ORIGINATION FORM

Proposed Revisions to a Standard Plans Index

Index Number: 521-630

Index Title: PARAPET WITH C-I-P SIDEWALK - WALL COPING

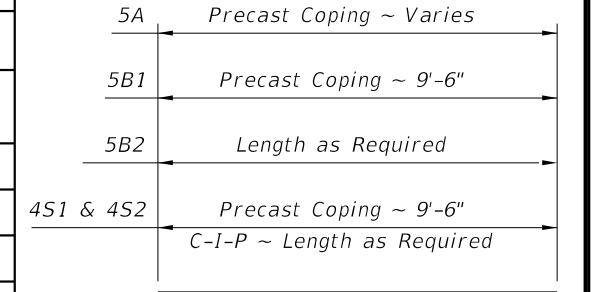
Changed footing depth below sidewalk to 18" from 10"; Updated the name of the barrier to Shoulder Barrier from Concrete Barrier Wall; Changed C-I-P Buildup Concrete (1'-1" Max.) callout in the TYPICAL SECTION THRU PRECAST COPING/PARAPET WITH C-I-P SIDEWALK AND RETAINING WALL to C-I-P Class NS Concrete (1'-1" Max.)

This Standard needed some updating to keep consistency with current barrier footing dimensions.

CIP buildup concrete type was never clarified. SDO review deems Class NS is acceptable because the concrete buildup section is not meant to transfer any meaningful load to the wall other than self weight.

TYPICAL SECTION THRU PRECAST COPING/PARAPET WITH C-I-P SIDEWALK AND RETAINING WALL (MSE Wall Shown, other Wall Types Similar)

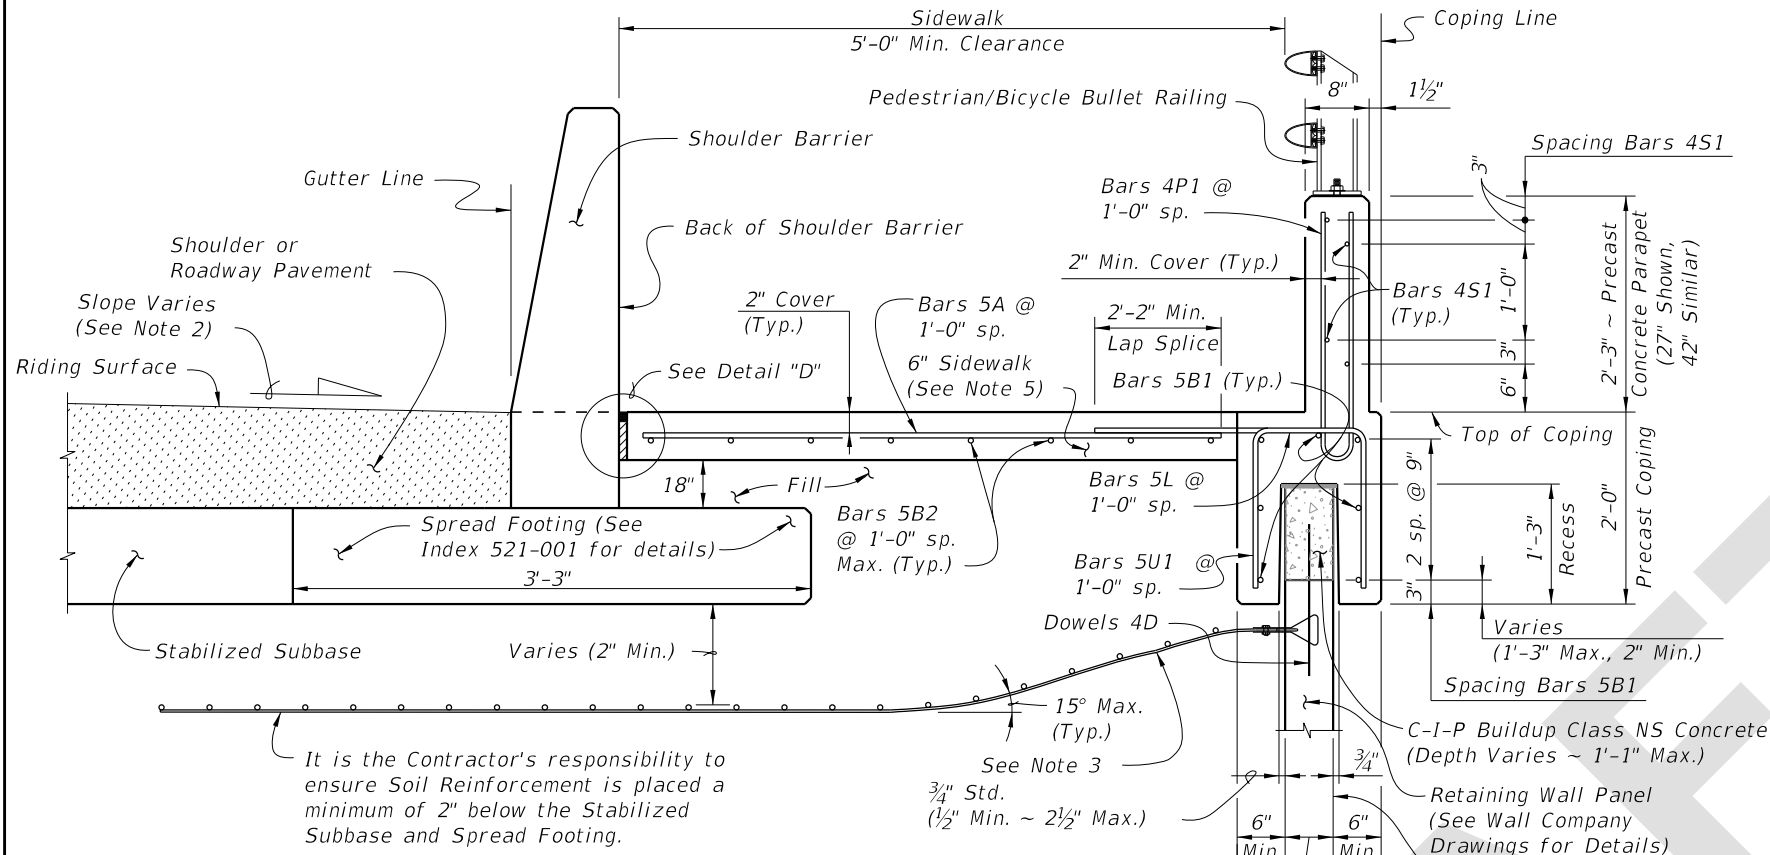
CHANGED DEPTH TO: 18"

UPDATED TO: Shoulder Barrier

CHANGED DEPTH TO: 18"

ADDED DIMENSION: 3'-3"

CHANGED TO: Class NS Concrete
